ONS-2016-025

Subject: Completion of Required Action by NRC Order EA-12-051 with Regard to
Reliable Spent Fuel Pool Instrumentation

ENCLOSURE 2
Oconee Nuclear Station Units 1, 2 and 3,
ISE RAI responses and NRC Audit Report Open Items

FIGURE 1

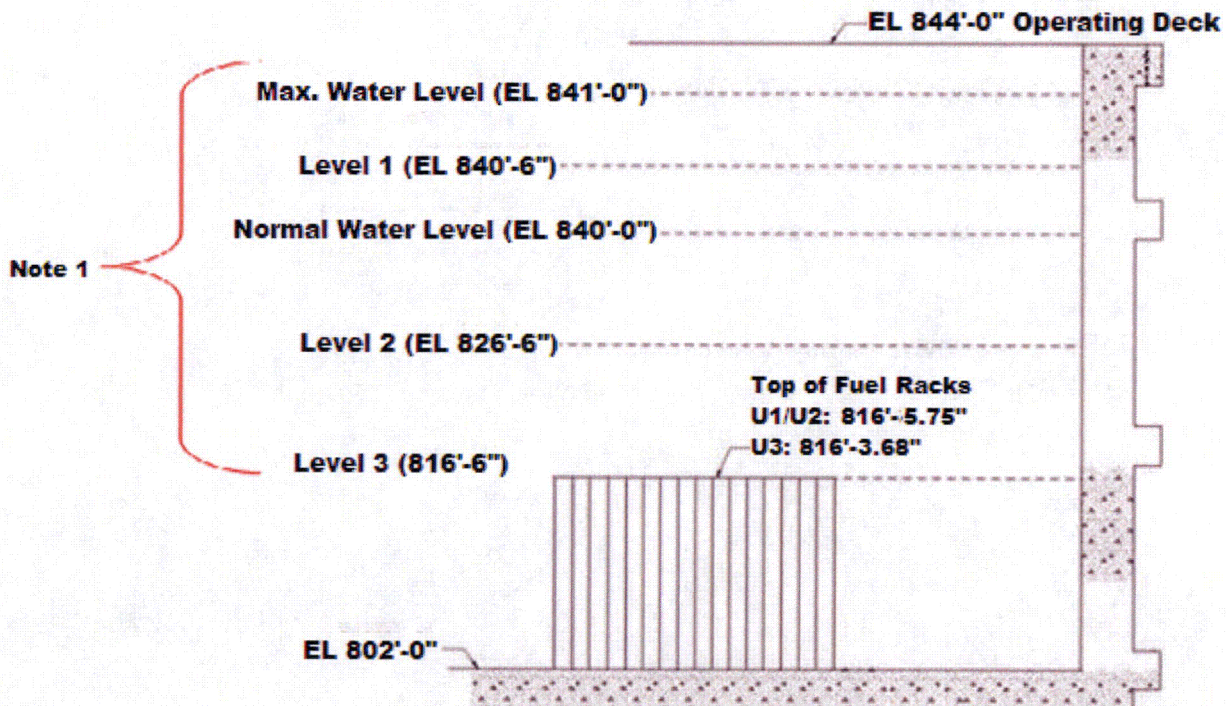
Please provide a sketch showing the approximate location of the SFP level instrumentation sensors and the elevations identified as Levels 1, 2 and 3 for the Unit 3 SFP.

Reference revision 20G of general arrangement drawing O-912-A for the location of the two sensors for the Unit 1&2 SFP and reference revision 29B of general arrangement drawing O-2912 for the location of the two sensors for the Unit 3 SFP. Refer to Figure 1 for the elevations representing Level 1, Level 2 and Level 3, the top of the fuel and the level monitoring range. Note that the elevation of the top of the fuel racks is 2.07" higher on the Unit 1&2 SFP than the Unit 3 SFP. Given this difference is small and well within the criteria specified in NEI 12-02 for Level 3 monitoring (+/- 12 inches from the top of the fuel racks), Level 3 is defined as 816'-6" for both the Unit 1&2 and Unit 3 SFPs for convenience.

Level Range EL. 816' - 6" to EL. 841' - 0"

Note 1: Level 1, Level 2 and Level 3 are applicable to both the Unit 1&2 SFP and the Unit 3 SFP. The range of the level indication will meet or exceed elevations defined by the maximum pool level (841'-0") and Level 3 (816'-6").
